Access Compliance Report

Public Rights-of-Way

Intersection ID: 10018631	Main Street: AGAVA_LN	Cross Street: N/A	Location: E
ADA ID: 45436CEFD39D	Ramp Type: Perp	Initial Pass/Fail: Pass	Overall Compliance: No
Severity Score: 0			
Codes/Mitigation Info/Possible Solution		Field Measurements/Component Compliance

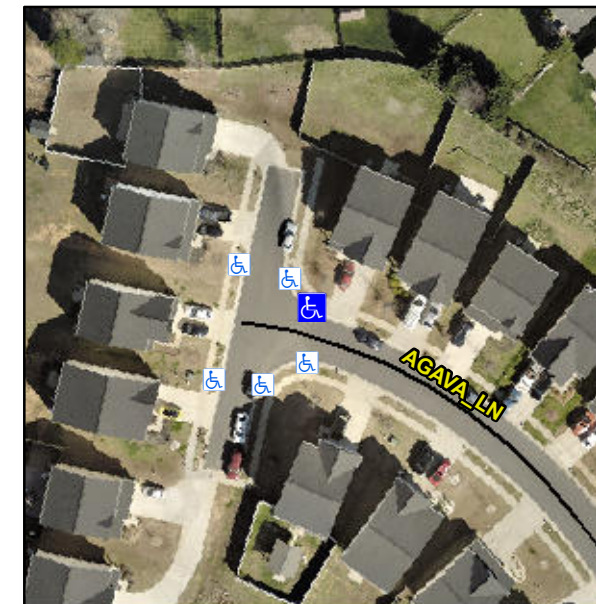
Not Found, R304.2.1, R304.2.2-Perp, R304.3.2-Para, R304.5.3, R305.2, R302.7

Compliance	Description	Data	Compliance	Description	Data
N/A	Ramp Length (in)	51.0	Yes	Ramp Slope (%)	7.5
Yes	Ramp Width (in)	48.0	Yes	Ramp XSlope (%)	0.9
N/A	Flare Type LT	Sloped	N/A	Flare Type RT	N/A
N/A	Flare Slope LT (%)	5.6	N/A	Flare Slope RT (%)	6.8
N/A	Flare Traversable LT?	No	N/A	Flare Traversable RT?	No
No	Landing Length (in)	42.5	Yes	DWS Provided?	Yes
Yes	Landing Width (in)	48.0	Yes	DWS Contrast?	Yes
No	Landing Slope (%)	3.7	Yes	DWS Length (in)	24.0
No	Landing X Slope (%)	3.5	Yes	DWS Full Width?	Yes
N/A	Landing Curb? (Y/N)	No	No	DWS Offset (in)	4.0
N/A	Shared Landing?	No			
No	Gutter Ponding?	Yes	Yes	Gutter Slope (%)	2.4
Yes	Gutter Lip Ht (in)	0.0	Yes	Gutter X Slope (%)	0.5
N/A	Painted X Walk1?	No	N/A	Painted X Walk2?	N/A
	X Walk 1 Direction	To S		X Walk 2 Direction	N/A
N/A	X Walk 1 Width (in)	N/A	N/A	X Walk 2 Width (in)	N/A
	X Walk 1 Slope (%)	0.4		X Walk 2 Slope (%)	N/A
	X Walk 1 X Slope (%)	1.8		X Walk 2 X Slope (%)	N/A

N/A	Ramp inside XWalk1?	N/A	N/A	Ramp inside XWalk2?	N/A
	Road Slope (%)	N/A	N/A	Clear Space?	Yes
	Road X Slope (%)	N/A	N/A	Clear Space to XWalk (in)	N/A
Yes	Any Obstructions?	No	Yes	Storm Grate/Utility Hazard?	No
	Obstruction Type			Storm Grate/Utility Type	
		N/A			N/A
			Yes	Surface Condition? (G/P)	Good

Remove & Replace Entire Ramp.
